# **Mobile Pentium® II Processor Specification Update**

Release Date: May 1999

Order Number: 243887-010

Old Mobile Pentium® II Processor in Mini-Cartridge Package Label with Supplier Matrix Mark

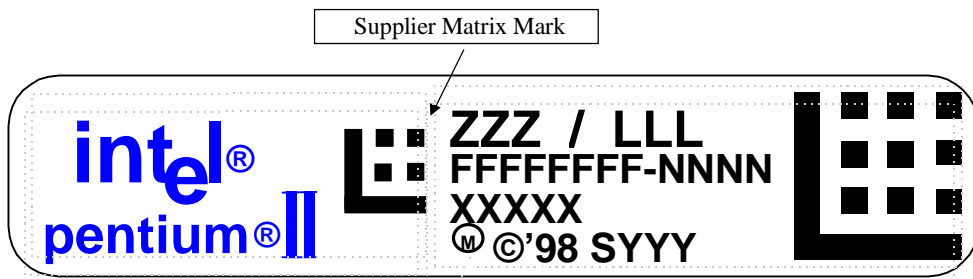
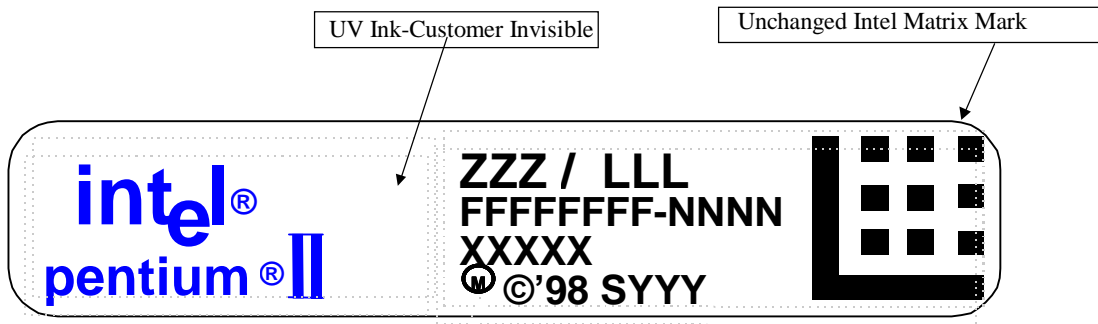
New Mobile Pentium® II Processor in Mini-Cartridge Package Label with Supplier Matrix Mark Removed

Figure 5.6. Cross Sectional View with Vertical Dimensions

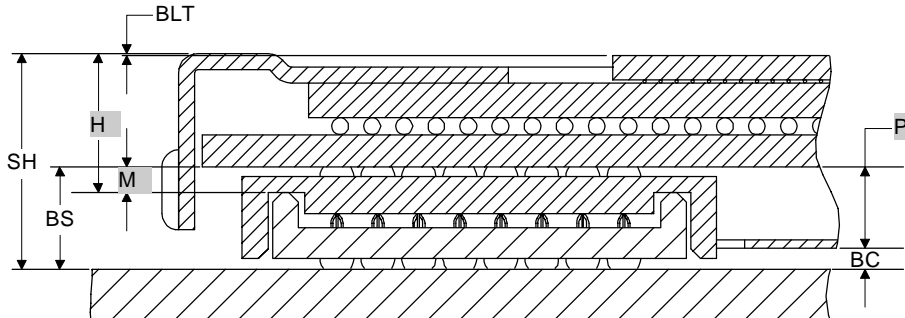
### B1. Misabeled Vertical Dimension Parameters

Figure 5.6 in the *Mobile Pentium® II Processor at 233 MHz, 266 MHz, and 300 MHz* datasheet should be replaced by the following figure:

Figure 1. TAP Gageable Thread Clarification

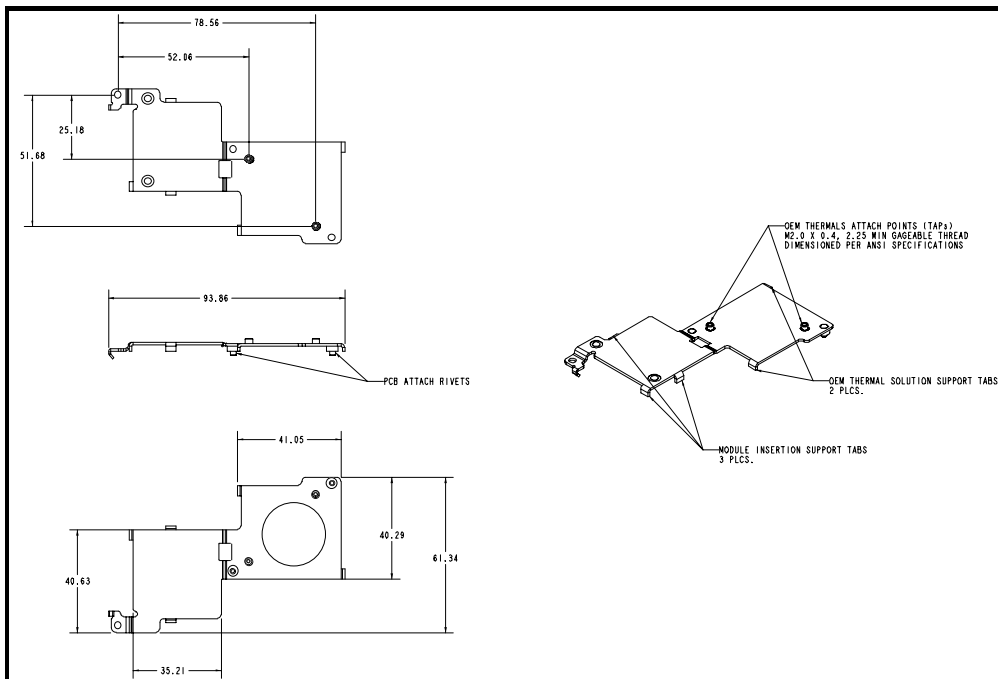
In the *Intel® Pentium® II Processor Mobile Module : Mobile Module Connector 1 (MMC-1)* and *Intel® Pentium® II Processor Mobile Module : Mobile Module Connector 2 (MMC-2)* datasheets (Order Numbers 243667 and 243668, respectively), the thermal attach point (TAP) gageable thread specification was not clearly identified in Figure 14, of Section 5.2. The following is the TAP clarification:

See Figure 1 below for more information.

OEM Thermal Attach Points (TAPs) M2.0 x 0.4, 2.25 min gageable thread dimensioned per ANSI specification.
